MPC5121e Functional Differences
2M34K and M36P
M. Ruthenbeck
12/2008

There are 3 major categories of the changes being made between the two mask sets, or revisions for the MPC5121e. These categories are 1) Feature enhancements, 2) System Enhancements, and 3) Bug fixes and maintaining pin compatibility between the 2 revisions.

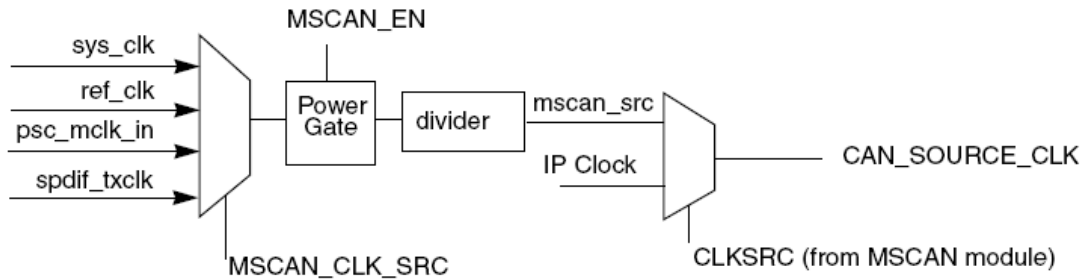
Can Clocking

The CAN clocking has been changed to enable greater granularity of the clock generation in support of additional CAN frequencies. The clock tree for the CAN has been implemented as follows:

Figure 6-4. PSC (MCLK) Clock Generation¹

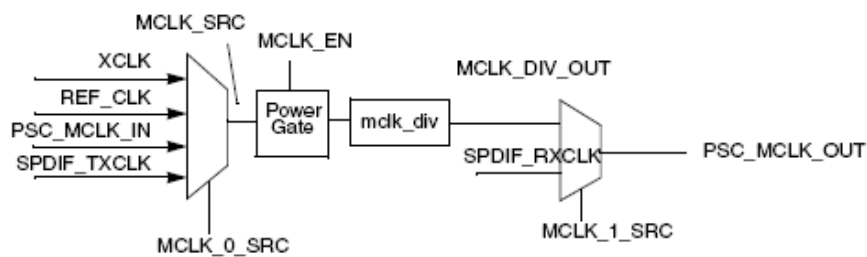
PSC Clock MCLK_DIV

The PSC MCLK_DIV has added a feature of a divide by 1, or pass through. The diagram below shows the “mclk_div” in the clock tree.
